1 INTRODUCTION

The City of Suisun City (City) prepared a Draft environmental impact report (Draft EIR) to evaluate the potential environmental effects of the proposed Highway 12 Logistics Center Project (proposed Project) in compliance with the California Environmental Quality Act (CEQA) (Public Resources Code Section 21000 et seq.) and the CEQA Guidelines (California Code of Regulations Section 15000 et seq.). As described in the Draft EIR, the proposed Project required a General Plan amendment, annexation, and pre-zoning of approximately 161 acres of land into the City of Suisun City. Approximately 93.4 acres of land would be developed (referred to as the ‘Development Area’) for warehouse and logistic uses, and the remainder would be Managed Open Space. Upon annexation, the proposed Development Area would be zoned Commercial Services & Fabricating (CFS) and the remaining Annexation Area would be zoned Open Space (OS) or would be within roadway rights-of-way. The Commercial Services & Fabricating zoning would accommodate light manufacturing, research and development, warehousing, and accessory office space. The Open Space zoning would allow agriculture, resource protection and re

Figure 2: Trip Generation Rates for Different Warehouse Categories (Trips Per 1000 Square Feet per Day)

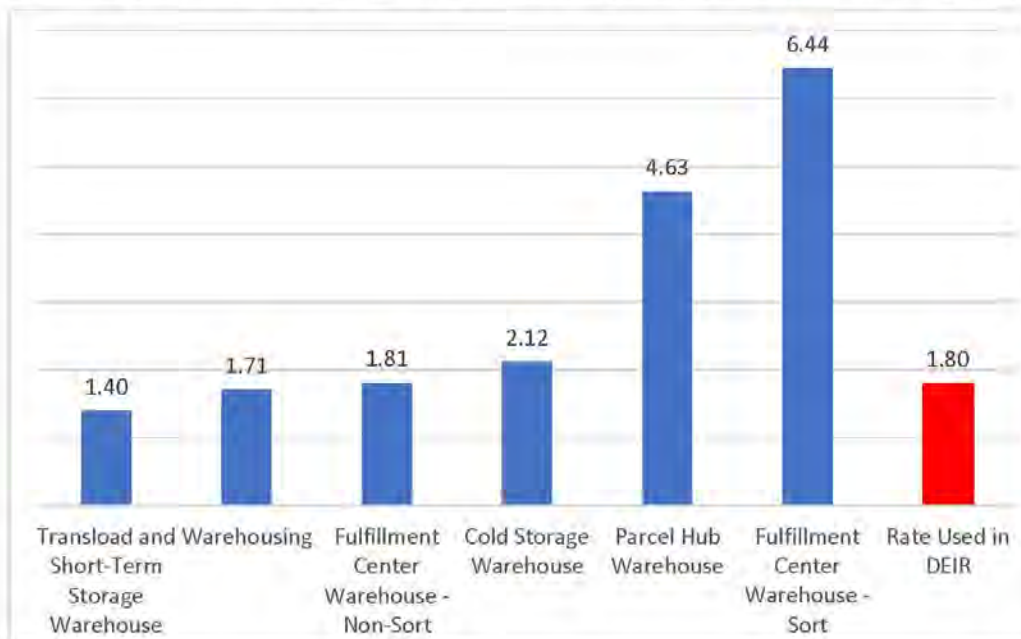
The project includes 1.28 million square feet. (DEIR, p. 3-10) The tenants have not been identified, and the nature of the operations are unknown at this time. The DEIR states that this would produce 2,310 trips per day. (DEIR p. 6-4) This is a rate of 1.8 trips per 1000 square feet per day. The DEIR fails to justify use of this trip rate.

The Institute of Transportation Engineers (“ITE”) *Trip Generation* manual. *Trip Generation* includes different warehouse categories. As shown in the figure below, the trip generation rate applied in the DEIR is much lower than rates for some other warehouse categories.

As shown in Figure 1 in an earlier section of this letter, the DEIR air quality CalEEMod analysis applied the category “Refrigerated Warehouse – No Rail.” Therefore, at minimum, the DEIR should use the Trip Generation rate of 2.12 for “Cold Storage Warehouse” rather than the lower value of 1.80 that was used.

4.9.3 Conflict with Existing Zoning for an Agricultural Use [page 4.9-11]

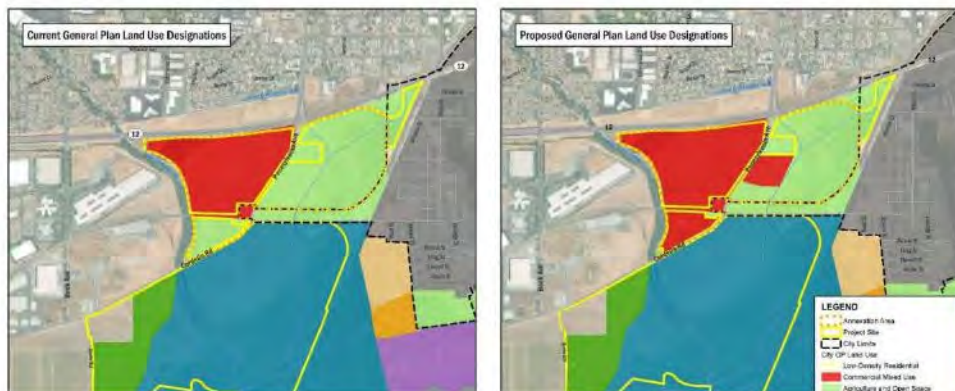
The draft EIR offers a confusing, legalistic interpretation in order to conclude that no impact would occur with regards to land zoned for agriculture. However, this is only because the project proposes to annex, and then re-zone, land that currently is zoned for agricultural use.

Response: Draft EIR Exhibit 3-5 (Chapter 3, “Project Description,” page 3-8), referenced by the commenter, shows the existing and proposed land use designations at the Project Site; it does not show the zoning. The proposed Project includes three Planning Areas, which together comprise the proposed Development Area. Planning Area 1 is a 69.6-acre development area north of the existing railroad tracks and west of Pennsylvania Avenue. Planning Area 2 is a 13.1-acre development area north of and immediately adjacent to Cordelia Road. Planning Area 3 is a 10.7-acre development area on the east side of Pennsylvania Avenue (see Draft EIR Table 3-1 [page 3-9] and Exhibit 3-8 [page 3-18] showing the Planning Areas). As shown in Draft EIR Exhibit 3-5, the City’s land use designation for Planning Area 1 is Commercial Mixed Use, and the City’s Land Use Designation for Planning Areas 2 and 3 is Agriculture and Open Space. Although the Project Site is within the City’s Sphere of Influence, it has not been annexed to the City and therefore the Solano County zoning still applies. The Solano County zoning for the entire Project Site north of Cordelia Road (which includes the entire Development Area, encompassed by Planning Areas 1, 2, and 3) is Exclusive Agriculture 40 Acres (A-40). The commenter correctly quotes from Draft EIR Section 4.9, “Land Use and Planning, Including Agriculture Resources, Population, and Housing,” (page 4.9-2) that the purpose of the A-40 zoning designation (per Solano County) is to preserve agriculture, including allowing agricultural-related support uses, excluding incompatible uses, and protecting the viability of the family farm. However, as noted above, most of the proposed Development Area (i.e., Planning Area 1, which encompasses 69.6 acres) has already been designated by the City for future Commercial Mixed-Use Development as part of the City’s 2035 General Plan (adopted in 2015). Therefore, the commenter’s issue does not lie with the proposed Project, but rather with the City’s designated and previously approved land uses in its adopted General Plan. Implementation of the proposed Project would change both the land use designations and zoning for Planning Areas 2 and 3 (23.8 acres of the Project Site) from Agriculture and Open Space/AG-40 to Commercial Mixed-Use/Commercial Services & Fabricating.

4.9.3 Conflict with Existing Zoning for an Agricultural Use [page 4.9-11]

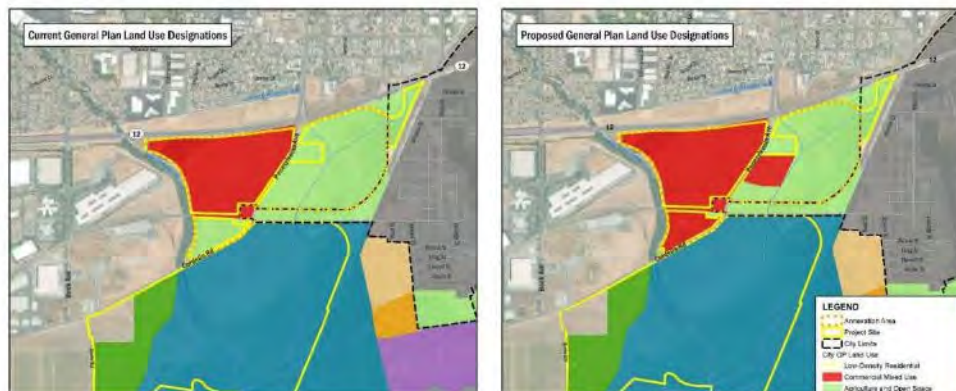
The draft EIR offers a confusing, legalistic interpretation in order to conclude that no impact would occur with regards to land zoned for agriculture. However, this is only because the project proposes to annex, and then re-zone, land that currently is zoned for agricultural use.
